Re: Item PG18.5 – Proposed Technical Amendments to By-law 569-2013

RE: Amendments to By-law 569-2013 (Section 200.15)

Proposed Adjustments to Accessible Parking Spaces
Submitted to the Planning & Growth Management Committee

Figure 1

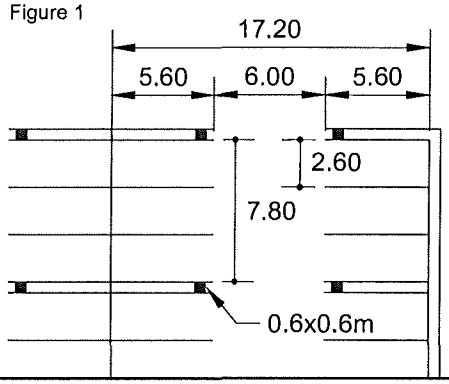
The impact to development of the proposed change is significant. The current width of 3 City of Toronto parking spaces (the typical number of spaces that fit within a typical structural grid in an above- or below-grade parking structure) is 7.8m plus the width of adjacent columns (Figure 1). Three typical spaces can be replaced with 2 AODA-compliant accessible parking spaces (3.4m "Type A" + 1.5m aisle + 2.4m "Type B" = 7.3m, Figure 2). Replacing 3 typical spaces with 2 proposal-compliant accessible spaces results in a required width of 8.3m (Figure 3). This exceeds the typical structural grid used in above- or below-grade parking facilities and may require structural changes near accessible spaces.

Our recommendation would be to adopt the sharing rules (between Type A and Type B spaces) as set out in the AODA and to adjust the length requirement to 5.6m so as to be compliant with the AODA and to be compatible with other critical zoning by-law parking dimensions.

Figure 4

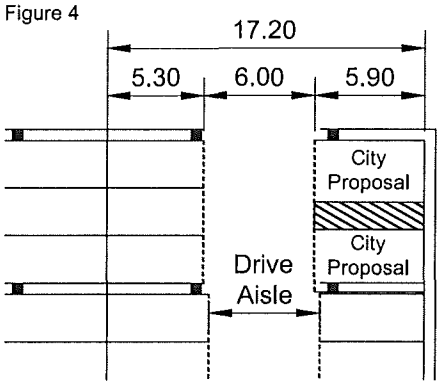
1) Drivers, travelling down the drive aisle, would see the 6.0m aisle "jog" to the side as they travelled, resulting in a less safe condition within the parking area (Figure 4).
2) Parking spaces opposite the barrier free spaces may become shorter (5.3m in length) which would require by-law relief (Figure 4). Without relief all parking spaces within the impacted zone would be forced to shift (with parking spaces also shifting the entirety of the parking area) or resulting in the creation of unusable space within the parking area (Figure 5).
3) If structural grids could not be adjusted to accommodate the shifts required by the longer spaces, some parking spaces might violate the City's "obstruction rule" within the By-law (200.5.1.10 (D)), resulting in the need to seek relief from the rule through a variance or Site Specific By-law (Figure 6).
